# SAN JOSE DATA CENTER SMALL POWER PLANT EXEMPTION

## Commission Decision

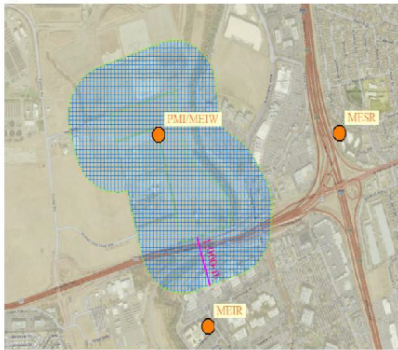
Response: See the above response to Data Request #68.
